ADDENDUM NO. 04

July 30, 2026

High School Addition & Renovation
Jr. High Addition & Renovation
Intermediate School Controls Renovations
Primary School Controls Renovations
Softball Concessions
Ellettsville, IN 47429

This Addendum consists of Pages ADD 4-1 through ADD 4-4 and attached Lancer Associates Architecture Addendum No. 4 dated July 30, 2026, consisting of ten (10) pages and 53 drawings.

1 **PLUMBING FOUNDATION PLAN - UNIT B3**
1/8" = 1'-0"

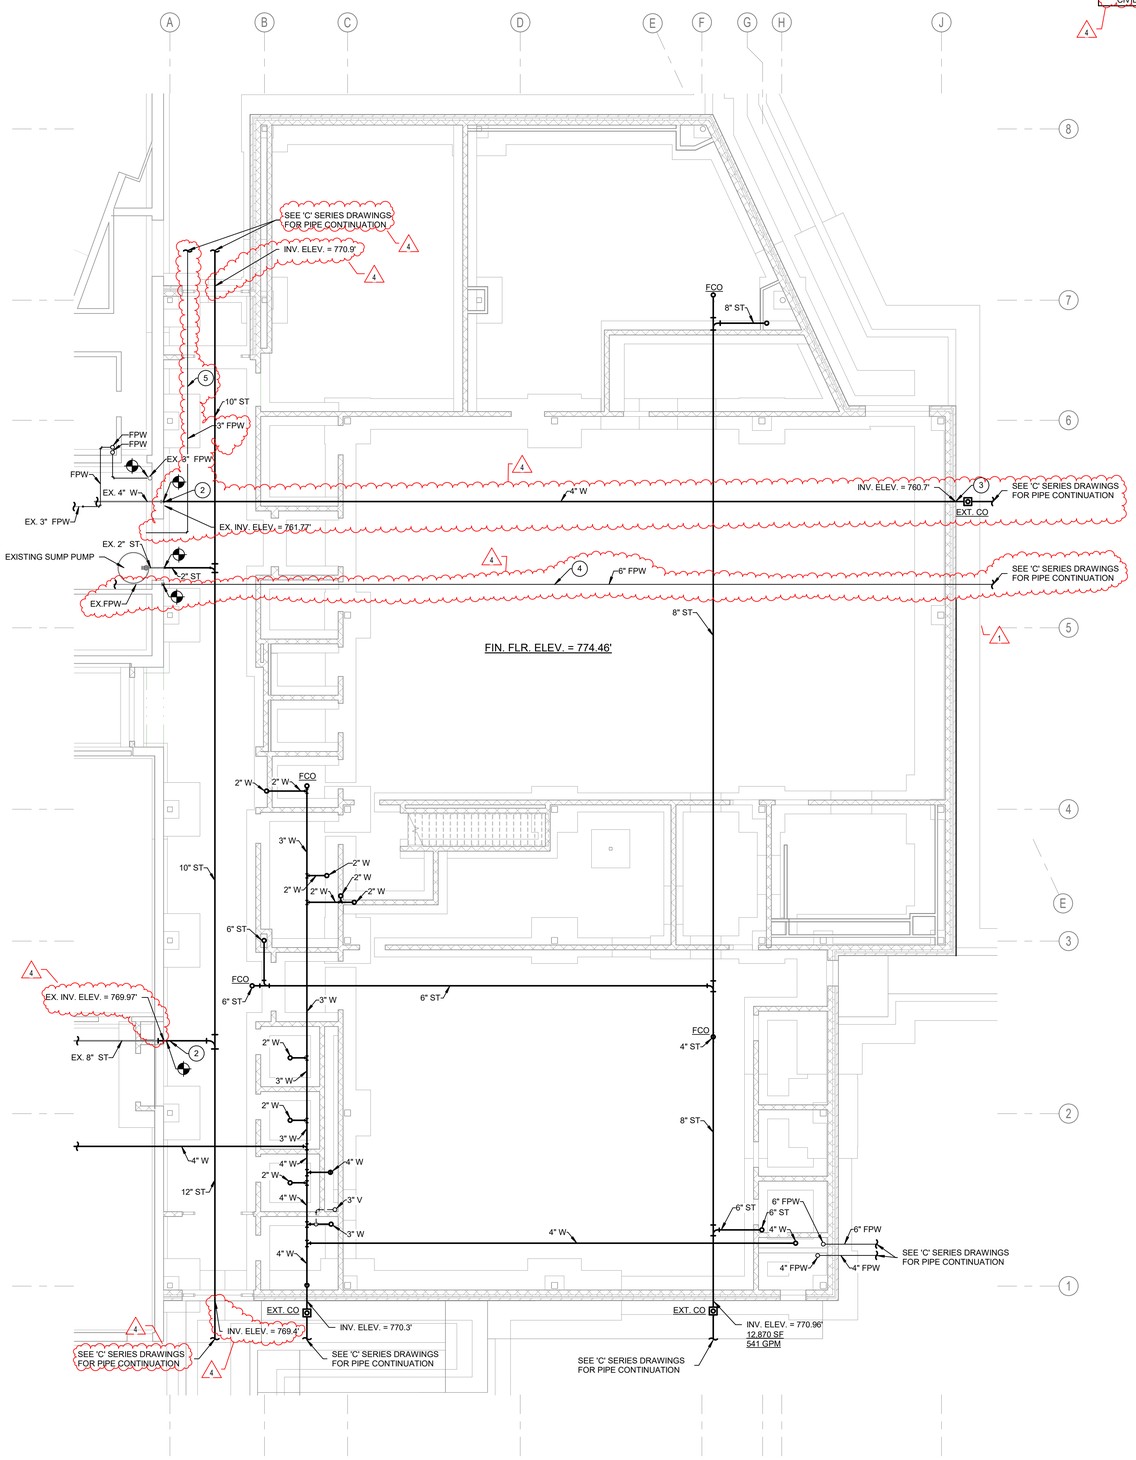
a. Revised text callouts to incorporate metal as finish material for detail 4/765.
18. Drawing PF102B3
    a. Update storm and sanitary pipe locations/inverts. Added temporary fire protection lines (for reference only)

1 **MECHANICAL PIPING FIRST FLOOR PLAN - UNIT A1**
1/8" = 1'-0"

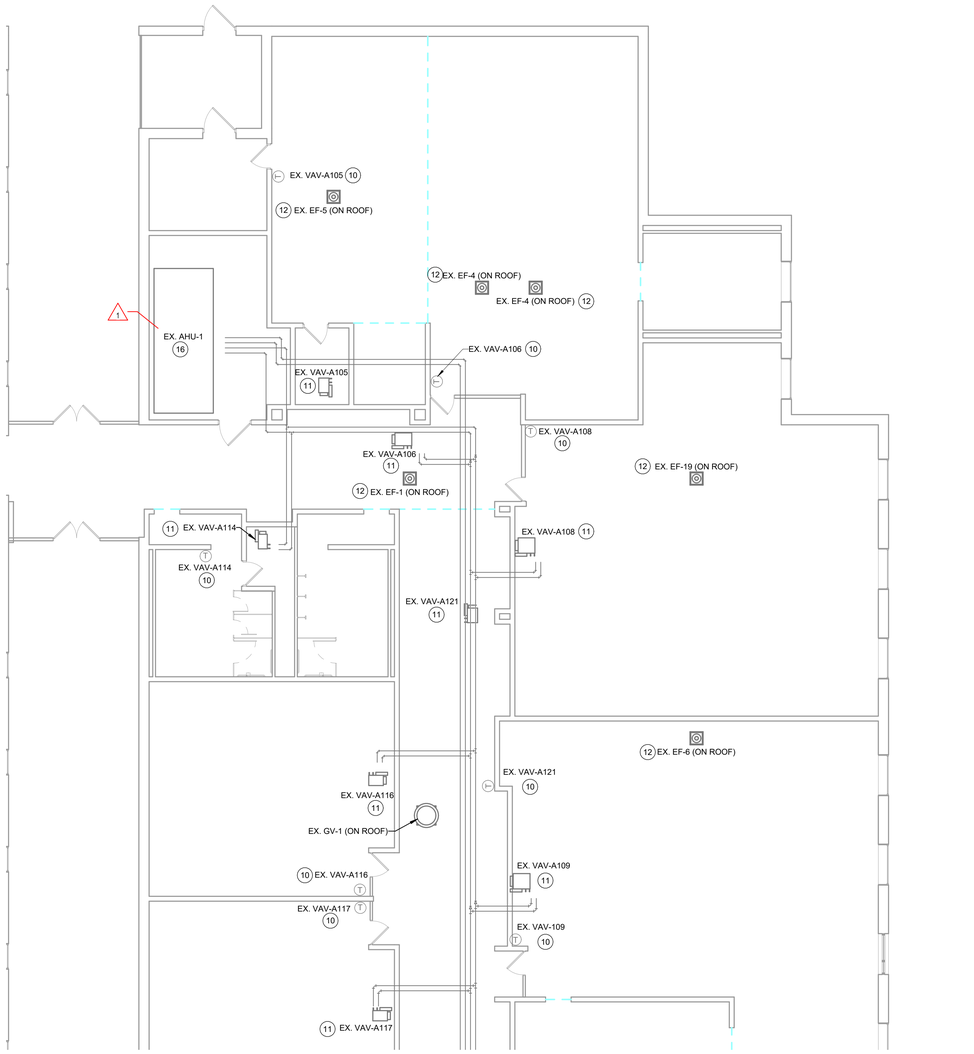
1. Note 16 on sheet MP101A1 States “Provide new variable frequency drive for each fan in AHU. TCC shall include disconnection and reconnection of electrical power connection of VFD by electrical contractor in its bid.
    a. Are new VFDs to be provided for all AHUs? YES
    b. Is TCC or electrical contractor responsible for installation and electrical power connection? REFER TO REVISED PLAN NOTE 16.
    c. Is an AHU schedule with motor horsepower/fan quantities available?

19. Drawing MH101B3
    a. Moved diffuser away from light location.
20. Drawing MP101A1
    a. Revised note 16
21. Drawing MP101A2
    a. Revised note 16
22. Drawing MP101B1

YES, SEE REVISED M-601 ATTACHED.
2. Sheet M601: EF-B2A says it is to be controlled by a toggle switch but also has note 2 which requires a fan speed controller. Is the fan single speed controlled by a switch or does it require a controller for modulating speed? SINGLE SPEED CONTROLLED BY A SWITCH, SPEED CONTROLLER IS USED FOR BALANCING PURPOSES ONLY.

GYM 277V LIGHTING CONTROL DIAGRAM

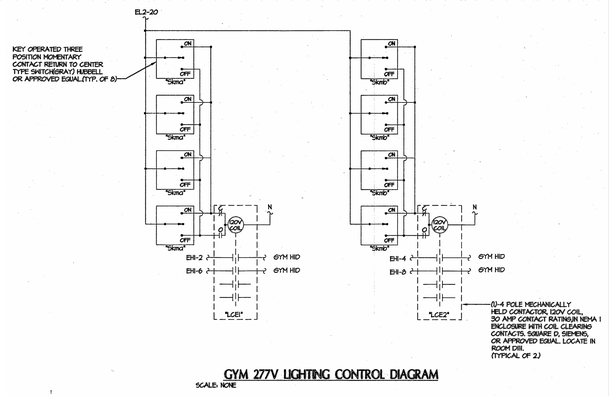
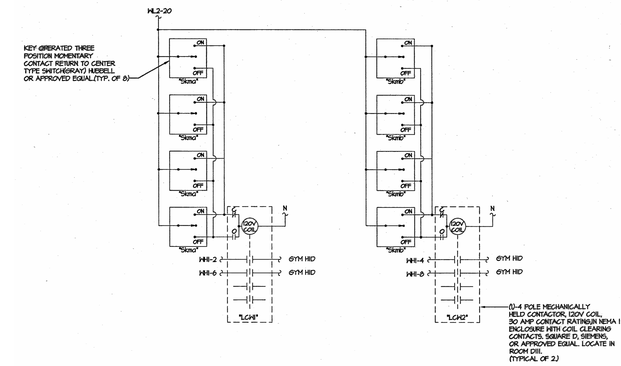
1. Drawing MH102
   a. Added note 13
2. Drawing MH103
   a. Added note 13
3. Drawing MH105
   a. Added note 13
4. Drawing M-701
   a. Added lighting control diagrams

1. Drawing MH101
    a. Added note 14
2. Drawing MH104
    a. Added note 14
3. Drawing MH105
    a. Added note 14
4. Drawing M-701
    a. Added lighting control diagrams
